# UNITED STATES PATENT AND TRADEMARK OFFICE

10/576,398

<b>Office Action Summary</b>	<b>Application No.</b> 10/576,398	<b>Applicant(s)</b> GERMAIN, JEAN-PIERRE	
	<b>Examiner</b> Denise R. Anderson	<b>Art Unit</b> 1797

### DETAILED ACTION

**Lozhkin et al. Figure: Filter for cryogenic liquids.**

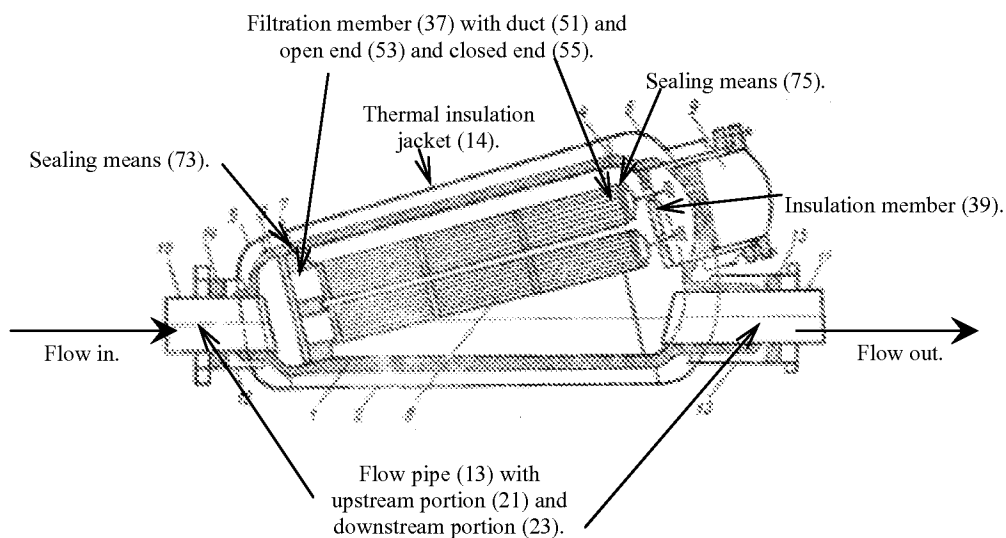
3. Claims 10 and 11-13 are rejected under 35 U.S.C. 102(b) as being anticipated by Lozhkin et al. (SU403926, Dec. 3, 1974 – The EPO abstract from the esp@cenet database, the Derwent abstract, the patent, and an English translation).
4. Regarding claim 10, Lozhkin et al. discloses “filters for cryogenic liquids.” Lozhkin et al., Translation, page 2, lines 2-3. The Lozhkin et al. installation is shown below, with the flow pipe (13) having a filtration member (37) and an insulation jacket (14).

5. Lozhkin et al. discloses a reversal of the flow through the apparatus relative to that of the invention. The recited "upstream" and "downstream" limitations of claim 10 do not distinguish the invention from Lozhkin et al. because apparatus claims must be structurally distinguishable from the prior art in order to be patentable. As is stated at MPEP 2114, " While features of an apparatus may be recited either structurally or functionally, claims directed to an apparatus must be distinguished from the prior art in terms of structure rather than function. *In re Schreiber*, 128 F.3d 1473, 1477-78, 44 USPQ2d 1429, 1431-32 (Fed. Cir. 1997) (The absence of a disclosure in a prior art reference relating to function did not defeat the Board's finding of anticipation of claimed apparatus because the limitations at issue were found to be inherent in the prior art reference)." As will be shown below in the instant case, the invention is not structurally distinguishable from the Lozhkin et al. installation.

6. In the above figure, Lozhkin et al. discloses that the filtration member (37) has a duct (51) through its center with an upstream open end (53) and a downstream closed end (55) with the duct being partially defined by the porous wall of filtration member (37). The duct (51) is known to exist from Lozhkin et al.'s description of the flow through the apparatus. Lozhkin et al. discloses "The flow medium enters via connection 11 into insert 8, in which it is filtered and then discharged from the filter through connection 10." Lozhkin et al., p. 3, lines 4-5. The filtration member also has a sealing means (73) at its lower end and a sealing means (75) at its upper end, as recited.

7. In the above figure, Lozhkin et al. further teaches that the flow pipe (13) has a double-walled thermal insulation jacket (14), with filtration members (37) secured inside. The flow pipe's upstream portion (21) emerges into the upstream open-end (53) of duct (51) through

sealing means (73). The flow pipe's downstream portion (23) emerges opposite the porous wall of filtration member (37).

8. In the above figure, the Lozhkin et al. also discloses that the flow pipe (13) has a branch extending parallel to the flow axis between upstream portion (21) and a free end. The branch contains two filtration members (37). The branch also contains insulation member (39) which is mounted to bear on the closed end (55) two filtration members (37) and the free end of the branch. Sealing means (75) are located between the filtration member (37) and the insulation member (39) and the sealing means (75) is maintained in compression.

10. Lozhkin et al. also anticipates claims 11-13, as shown in the above figure. The Lozhkin et al. sealing means (73) is maintained in compression by the filtration members (37) and the upstream portion 21 [claim 11]. The Lozhkin et al. upstream portion (21) is adjacent to the open end (53) leading in to the filtration members (37) [claim 12]. The angle between the branch portion and the flow axis is between about 10 and 30 degrees [claim 13].

**Lozhkin et al. Figure: Filter for cryogenic liquids.**

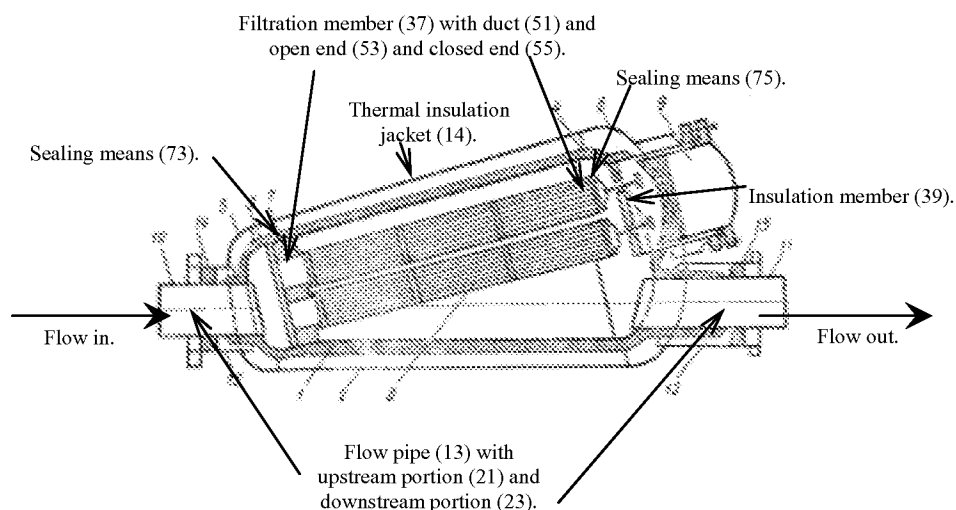
- a. Regarding claim 10, applicant argues, "Lozhkin fails to disclose, teach. or suggest all the limitations of the claims, including:
- a) a filtration member having a porous wall;
  - b) a duct formed in the filtration member and being at least partially defined by the porous wall;
  - c) the duct has an open upstream end;
  - d) the emergence of an upstream portion (21) of a liquid flow pipe (13) into an open end (53) of a duct (51) . . . via interposed sealing means 73; and
  - e) emergence of a downstream portion (23) of the liquid flow pipe (13) opposite a lateral region (59) of the porous wall (57) extending in the flow axis (Y-Y') along which the duct extends."
- Applicant's Remarks, p. 5, lines 9-21.

From the above figure, Lozhkin et al. discloses:

- a) a filtration member (37) having a porous wall;
  - b) the filtration member (37) has a duct (51) through its center with the duct (51) being partially defined by the porous wall of filtration member (37).

- c) the duct (51) has an open upstream end (53);
  - d) the emergence of an upstream portion (21) of a liquid flow pipe (13) into an open end (53) of a duct (51) . . . via interposed sealing means (73); and

- e) emergence of a downstream portion (23) of the liquid flow pipe (13) opposite a lateral region of the porous wall of the filtration member (37) extending in the flow axis along which the duct (51) extends.
